OPW Oifig na
nOibreacha Poiblí
Office of Public Works

Flood Map Update

MR018 Malahide

Version 1.0
March 2026

Figure 2-1; Tidal Flood Extent Map

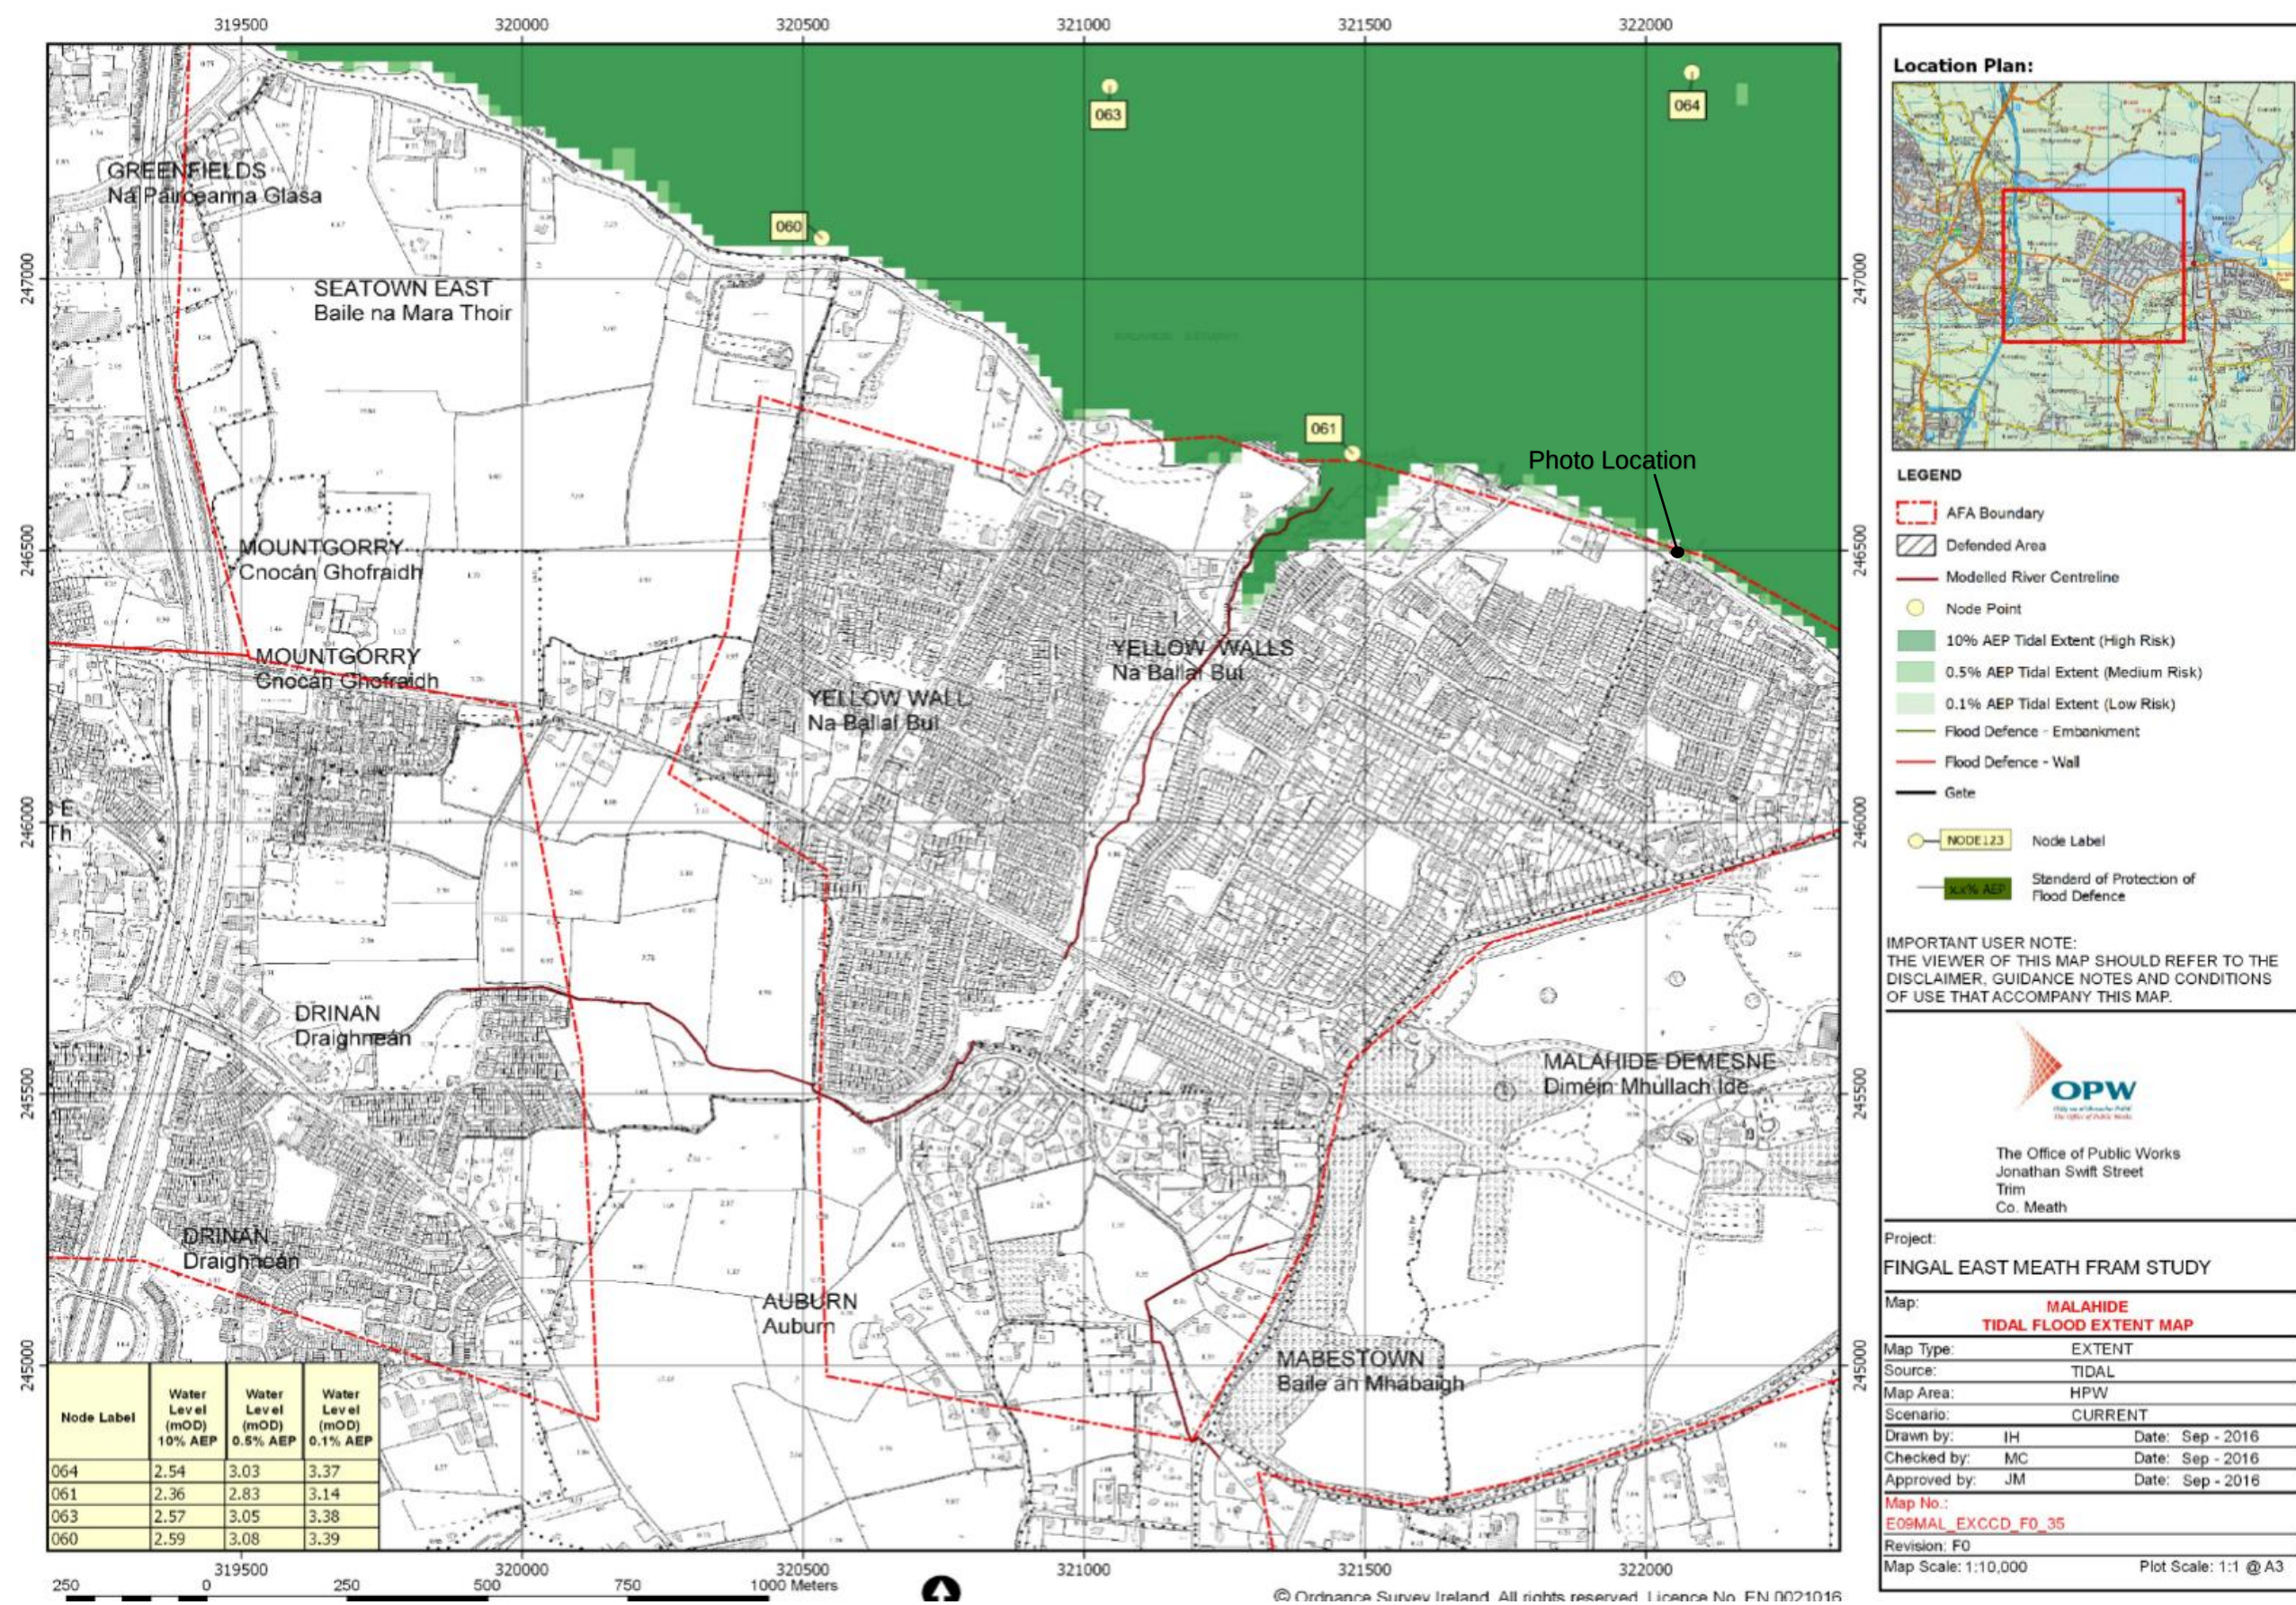
The OPW received correspondence from Fingal County Council that identified an issue with flood extents displayed on Floodinfo.ie. Fingal County Council provided evidence of flooding along Bisset Strand, Malahide, see Figure 2-1 for the photo location and Figure 2-2; Flooding on Bisset Strand, Malahide for the photo itself. This flooding is not shown in the CFRAM maps, which only show marginal flooding in all events for that area. As evidence was presented by a recent flood event which called into question the OPW published Flood Map, a Map Update is warranted. The OPW's Past Flood Database also indicates that the Bisset Strand and the Estuary Road areas are subject to recurring coastal flooding.

Figure 3-1; Overview of Affected Area

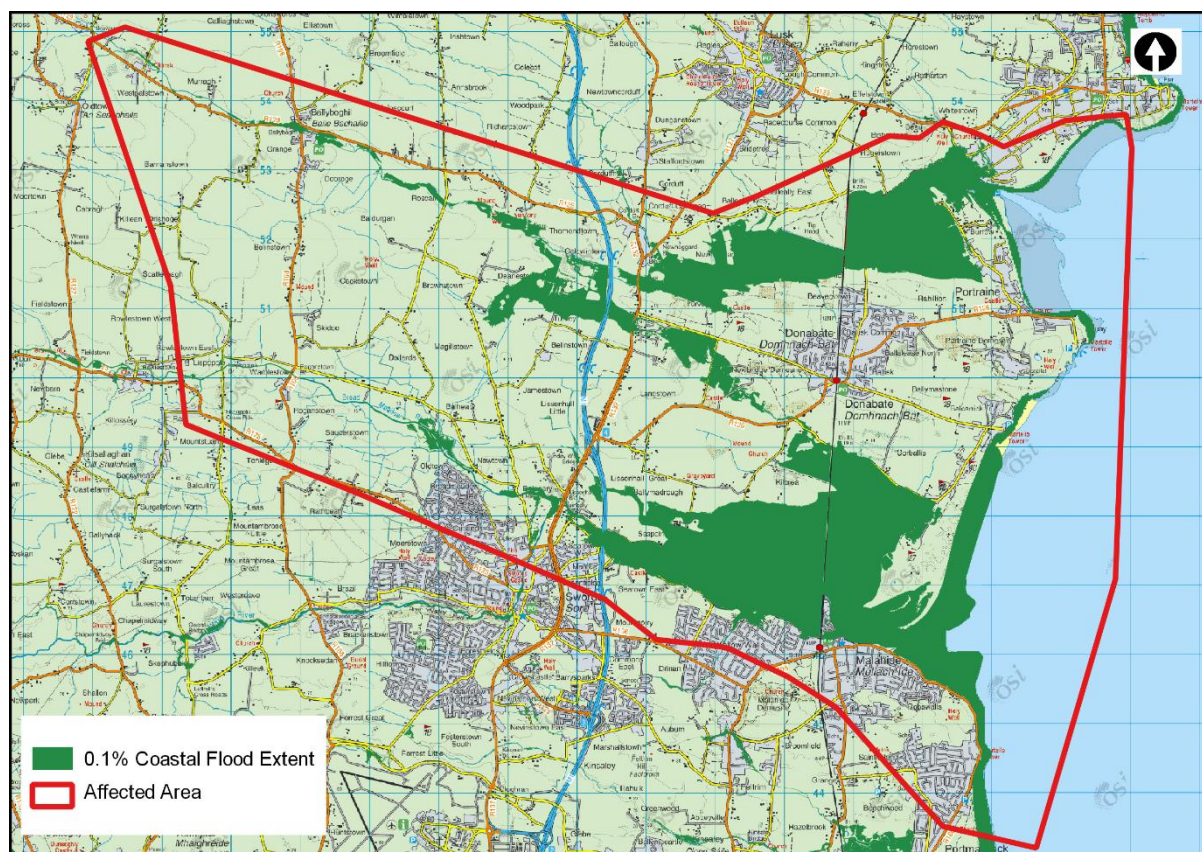
The coastal flood mapping in this area was produced by the Fingal East Meath Flood Risk Assessment & Management Study (FEMFRAMs). A review of the original data produced by the FEMFRAMs identified an error in the displayed coastal flood extents. The source data was then re-extracted from the FEMFRAMs hydraulic model results to provide appropriate flood maps. A further review identified that the issue was not constrained to Bisset Strand. The full extent is shown in Figure 3-1.

The data updated included the Current Scenario coastal flood extents, depths and node data for the area shown in Figure 3-1.

Figure 3-1; Updated Flood Map

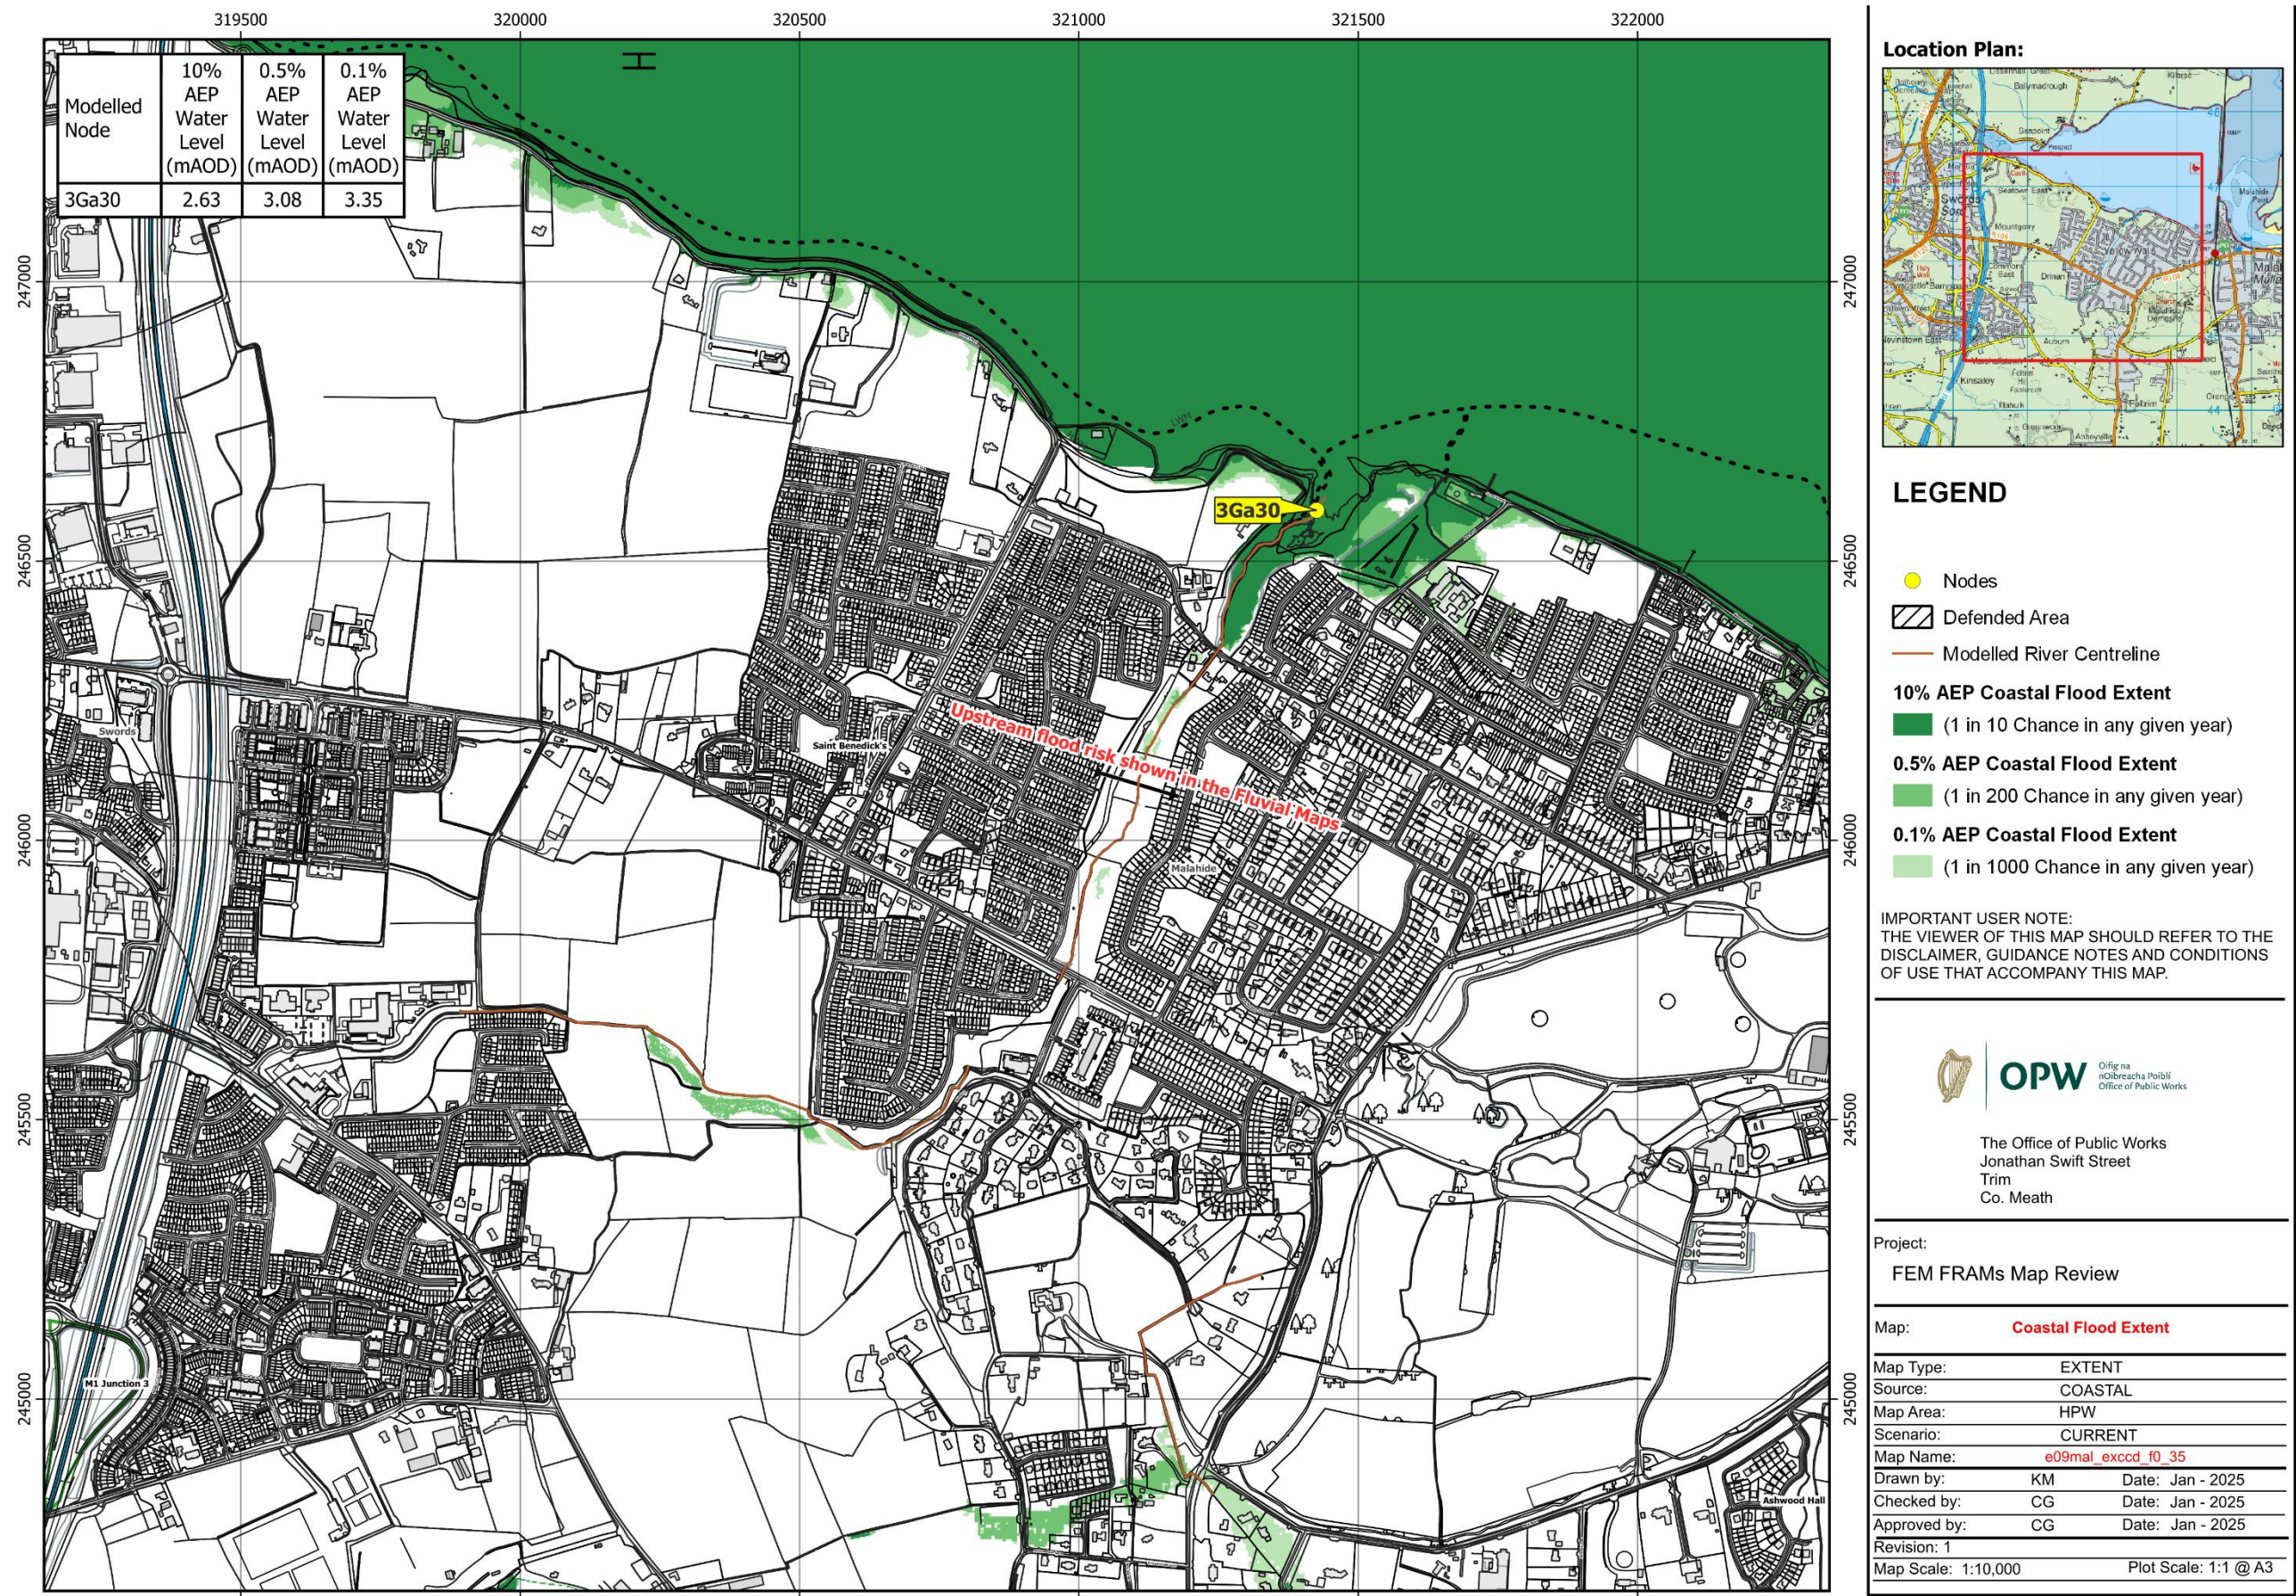
Evidence was presented for a flood event which called into question the published OPW Flood Map. Upon review it was determined that incorrect coastal flood extents and depths were originally extracted from the flood model, and the maps have been updated to reflect the correct model results. Bisset Strand is now shown within the flood extents, as supported by the available evidence, see Figure 3-1; Updated Flood Map
